1.2 31-33 HIGH STREET ROAD, ASHWOOD - USE AND DEVELOPMENT OF LAND FOR THE PURPOSE OF A FOUR STOREY MEDICAL CENTRE, DISPLAY OF SIGNAGE, REMOVAL OF VEGETATION AND ALTERATION OF ACCESS TO A TRANSPORT ZONE SCHEDULE 2 (TPA/54467)

The proposal is considered inconsistent with the relevant provisions of the Monash Planning Scheme and it is recommended that the application be refused.

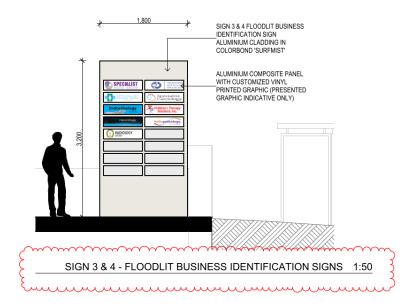
The Outdoor Advertising Policy at Clause 22.08 seeks to facilitate effective advertising for business which does not affect the amenity of residential uses. The specific objective for signs in Residential areas is to provide for unobtrusive identification signs respectful of neighbourhood character.

One business identification sign made of stainless steel 3D lettering will also specify the name of the centre and the site address and be located on the planter wall facing south. It measures 7.5 metres long by 400mm high.

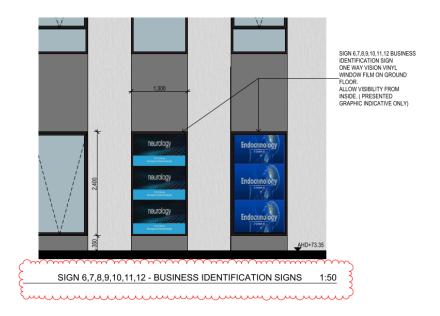
There are two blades (floodlit business signs) measuring 3.2 metres high by 1.8 metres wide containing the names of the specialists. These will be located at either end of the building within the front setback.
